**CORRESPONDENCE COVER SHEET  
WASTE PERMITS DIVISION  
TEXAS COMMISSION ON ENVIRONMENTAL QUALITY**

Date: April 25, 2019  
 Facility Name: City of Kingsville Landfill  
 Permit or Registration No.: MSW 235-C

Re: City of Kingsville Landfill – Kleberg County  
Municipal Solid Waste (MSW) - Permit No. 235C  
Permit Amendment Application – Notice of Deficiency  
Tracking No. 23301130, 23458984, and 24040819; RN102334570/CN600674246

On behalf of the City of Kingsville and in response to the Texas Commission on Environmental Quality's (TCEQ) March 27, 2019 Notice of Deficiency (NOD) letter, we hereby submit the enclosed response regarding the Permit Amendment Application for the above referenced MSW facility.

**FIGURE:  
 III.1-2**

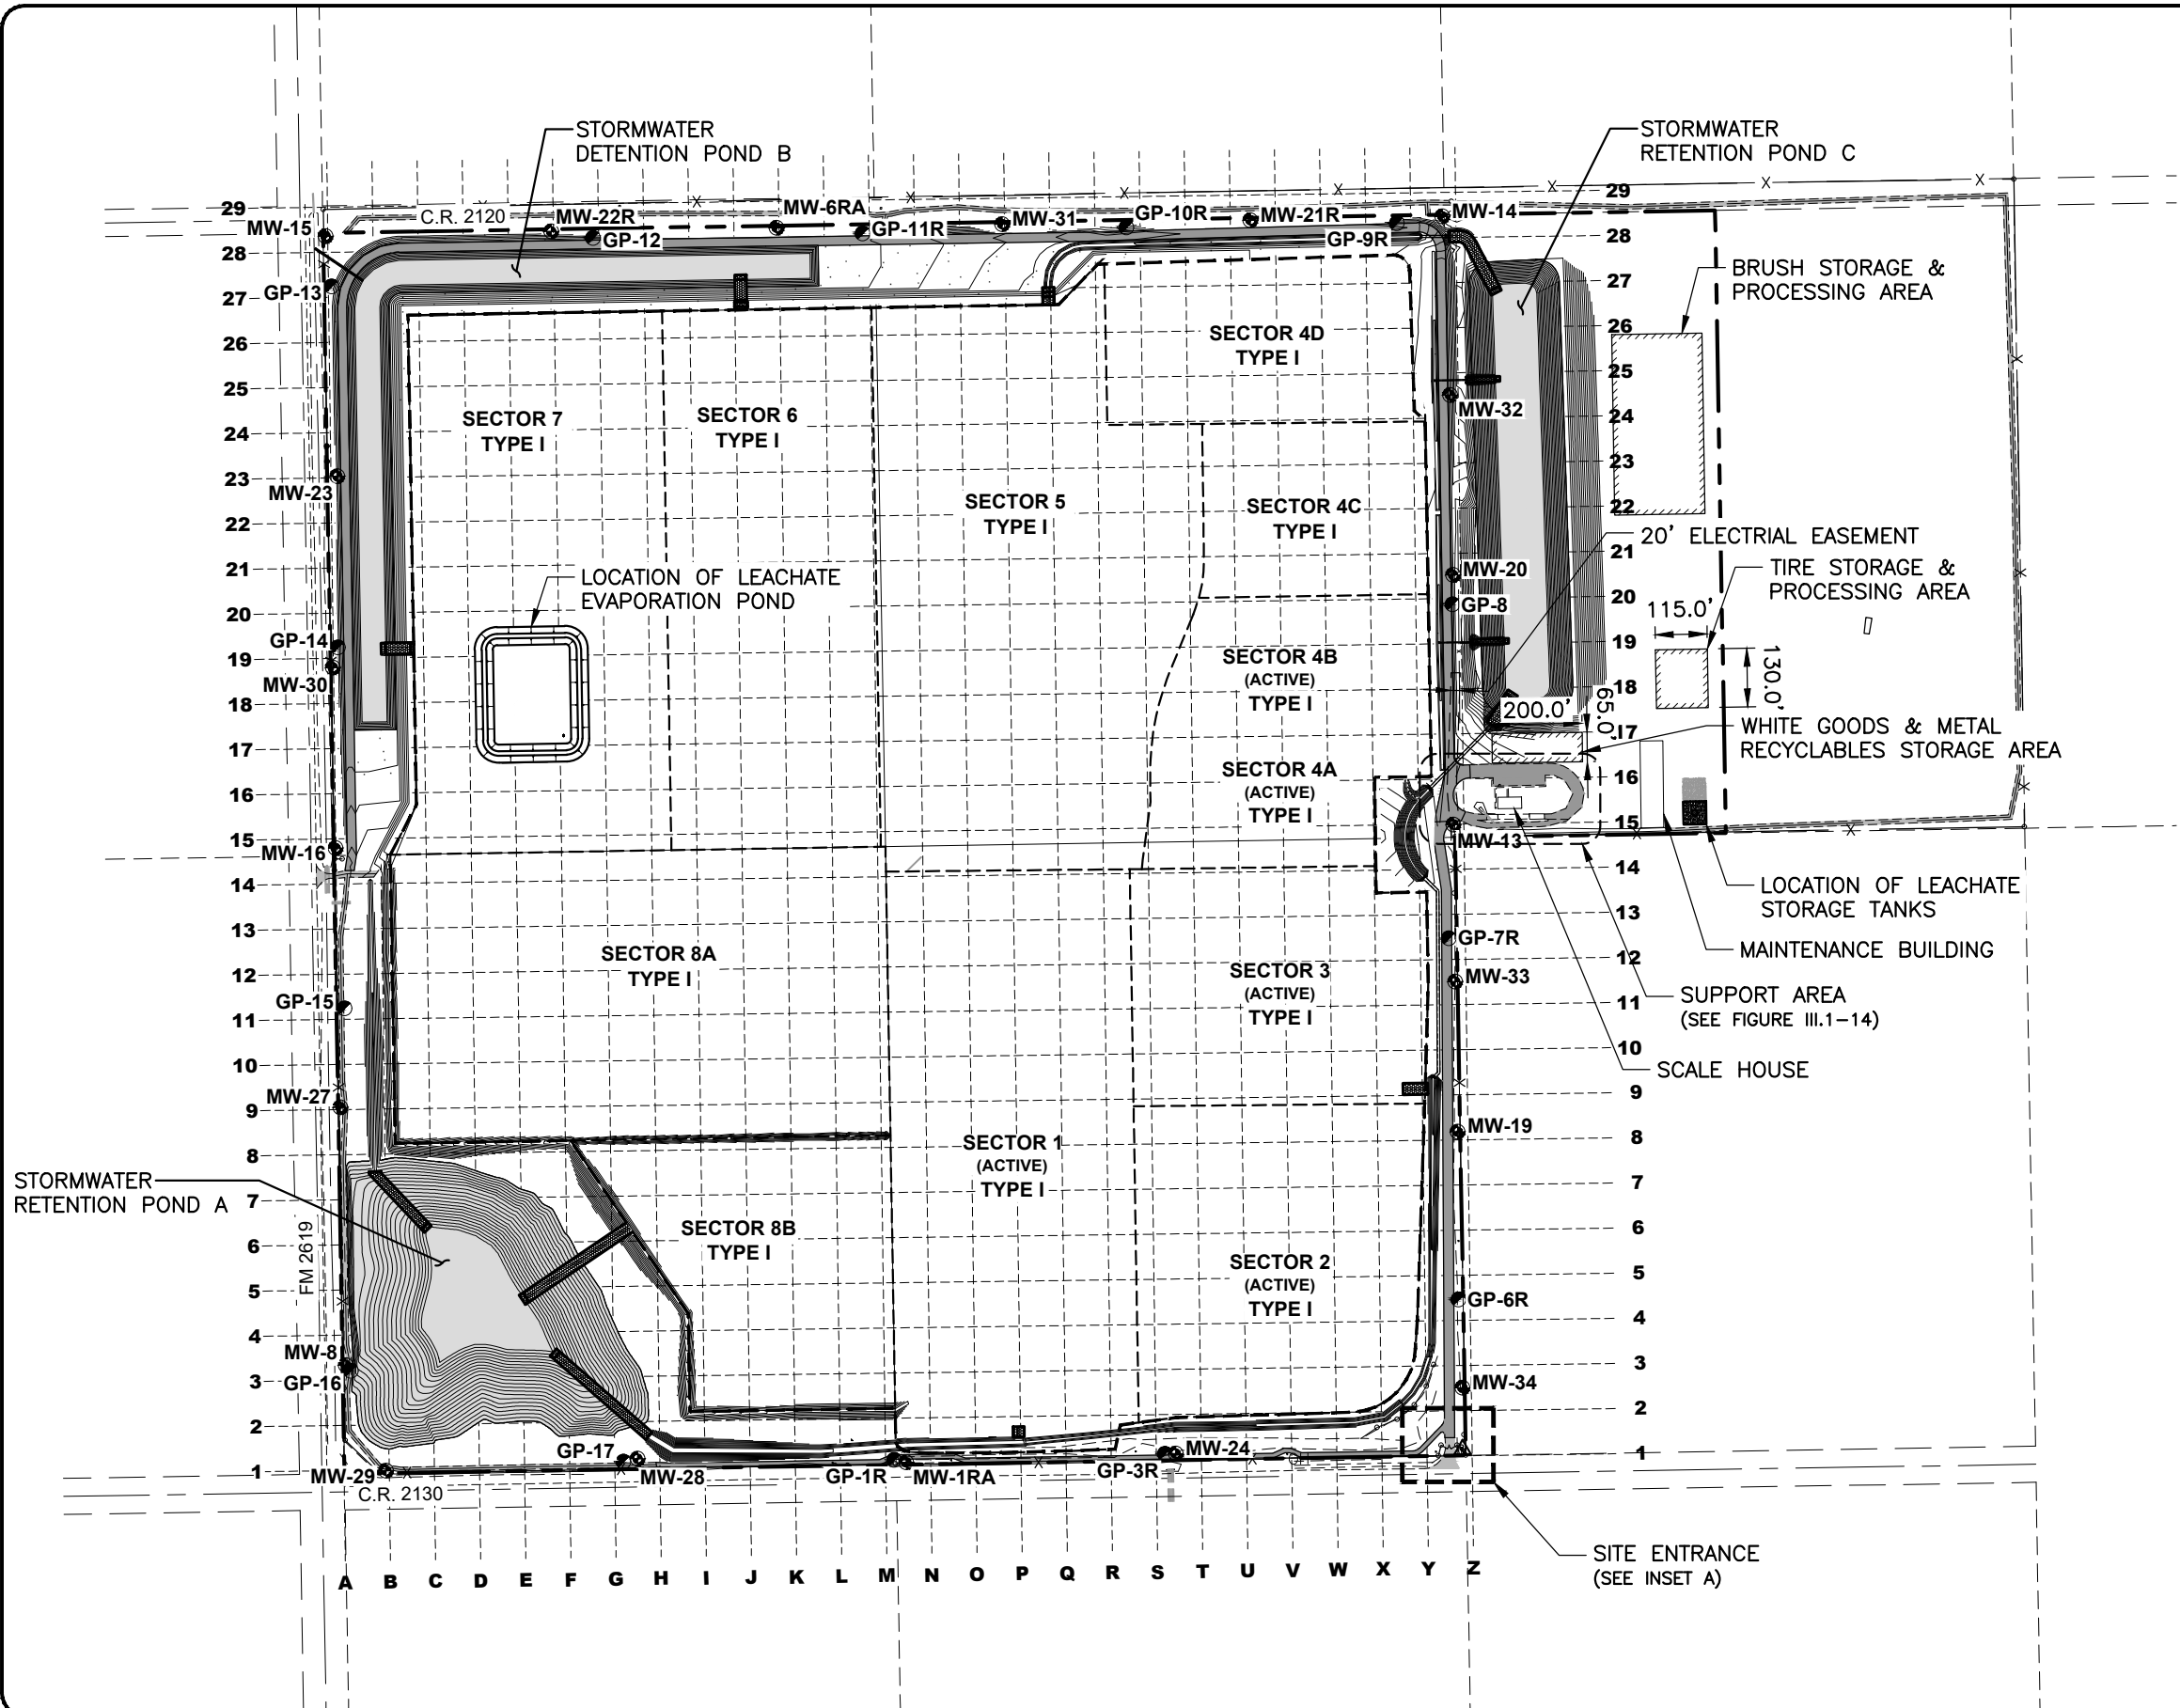
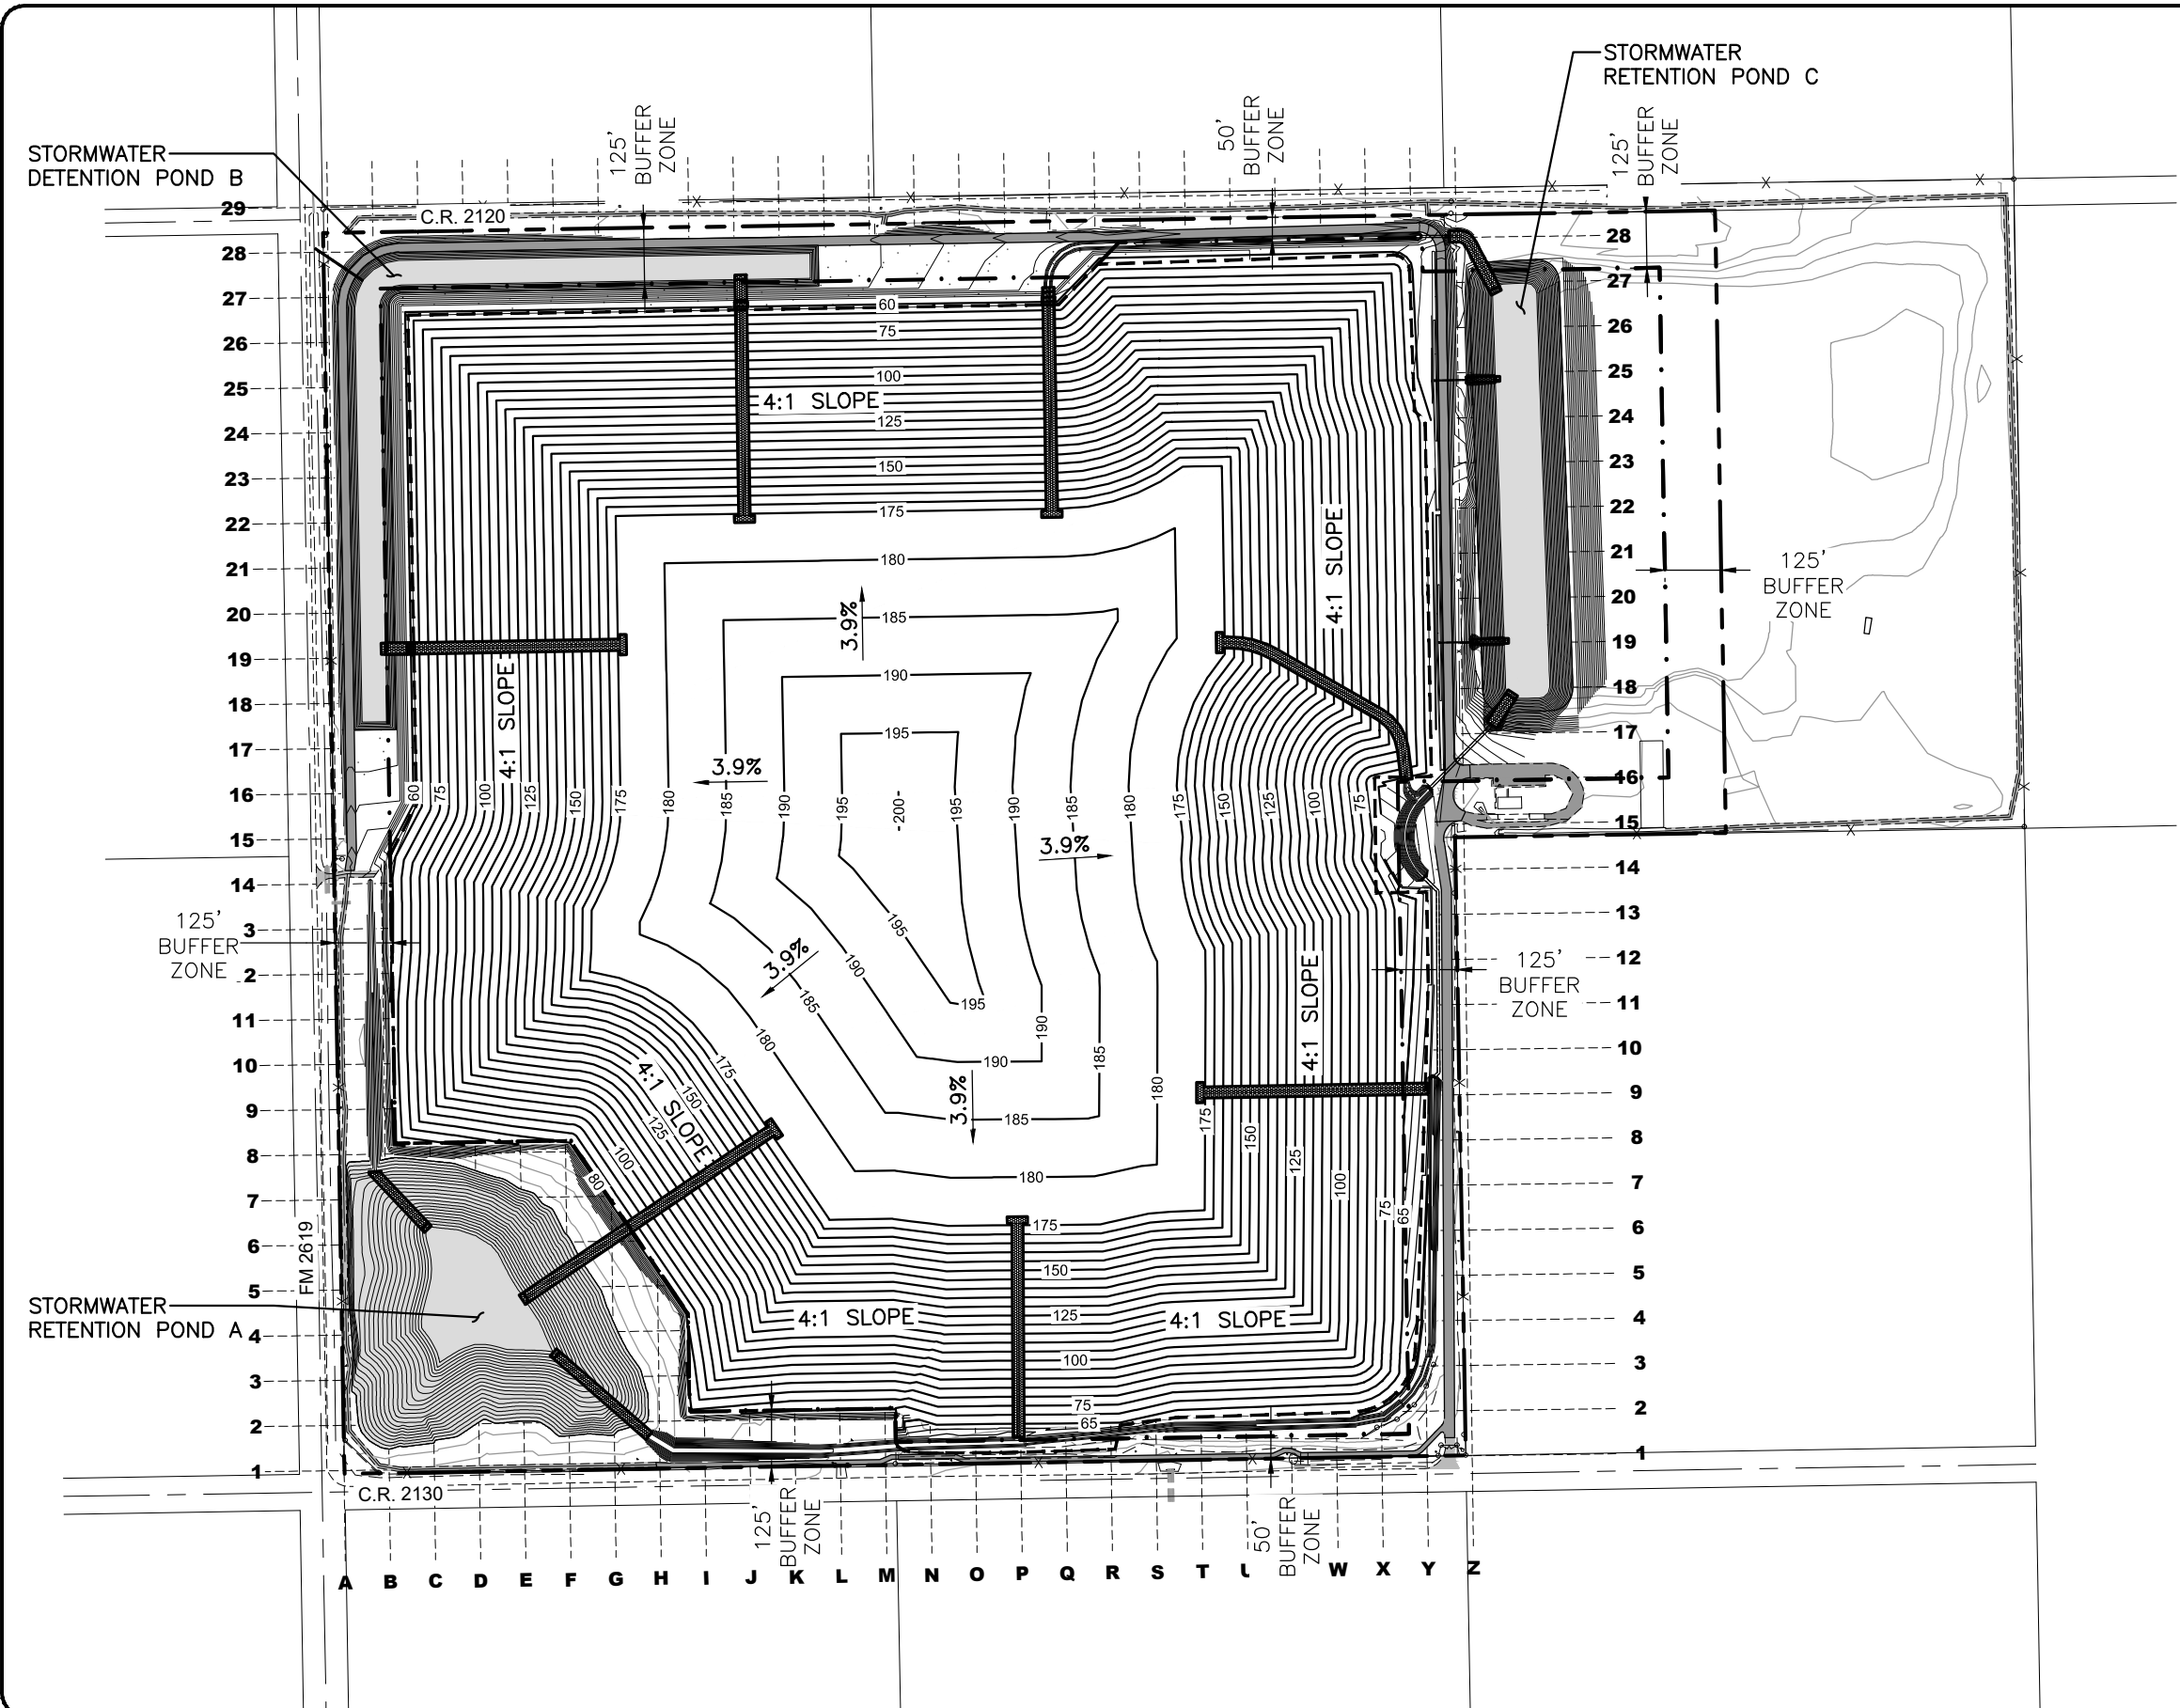
T7	277	Part III	330.63(b)(2)(D)	Vol 1, Sec 3.2.3, pg- 6	Inconsistent	Clarify if a liquid waste solidification facility is being proposed, and revise (also Part II, Sec 2, pg. 3-4, and Part IV, Att.5) Revise Figure III.1-2 to depict the solidification facility.	A liquid waste solidification area is proposed. Part II, Sec 2, pg. 3-4 has been revised. Part IV, Att.5 has been revised to include additional information regarding the design and construction of the liquid waste solidification area including Figure IV.5-1 Liquid Waste Solidification Area Construction Details. The Liquid Waste Solidification Area will be installed within an area that is operationally feasible and will periodically be relocated because of general sequence of filling operations. Due to the liquid waste solidification area being relocated periodically Figure III.1-2 was not revised to depict a permanent location. However Figure IV.5-1 was included in Part IV, Attachment 5 to depict the liquid waste solidification area layout and construction details.
